## 2AZ-FE Throttle Body

The purpose of this TSB is to provide updated throttle body part number information for certain vehicles equipped with the 2AZ-FE engine. The drain pipe has been eliminated on throttle body service parts. Please use the information below when replacing the throttle body assembly.

**Figure 1. Previous Throttle Body Assembly**

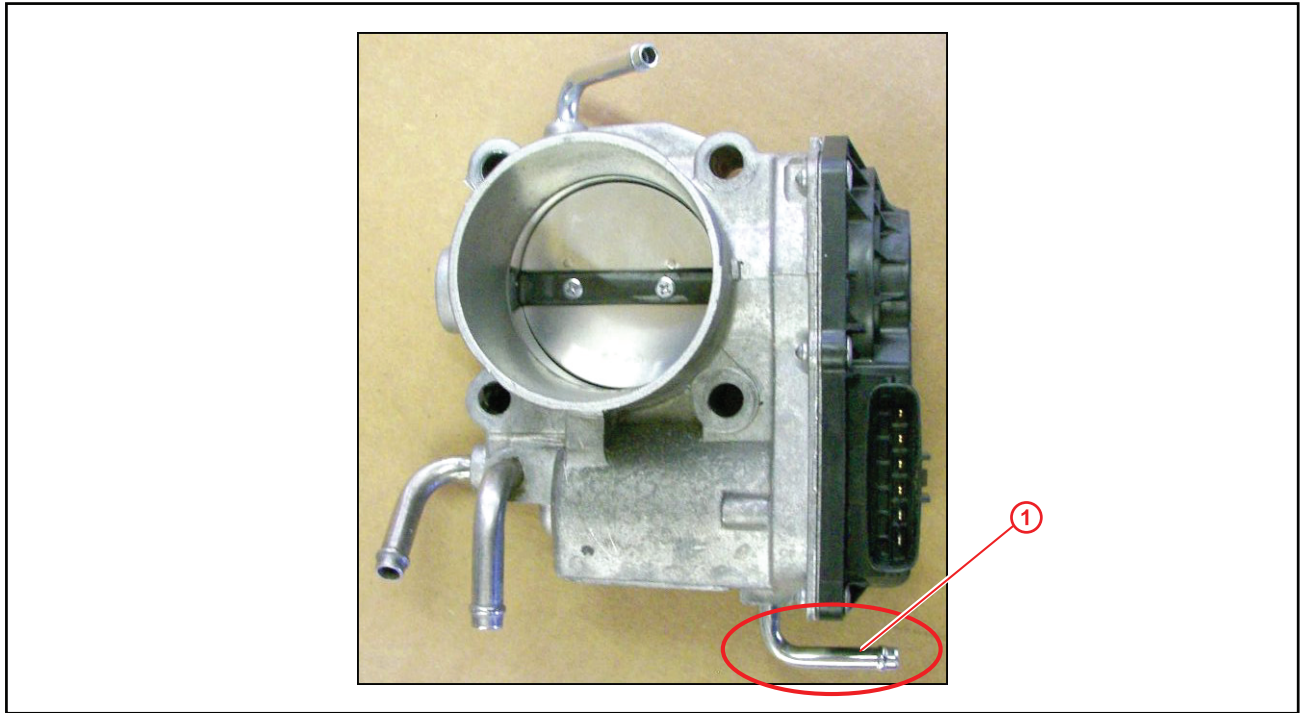
When replacing the throttle body assembly, remove and discard the throttle body hose that no longer has a port on the throttle body assembly. The port connected to the other end of the throttle body hose can be left open to the atmosphere — it does NOT need to be sealed.

<b>1</b>	This Port NOT on New Service Part
----------	-----------------------------------
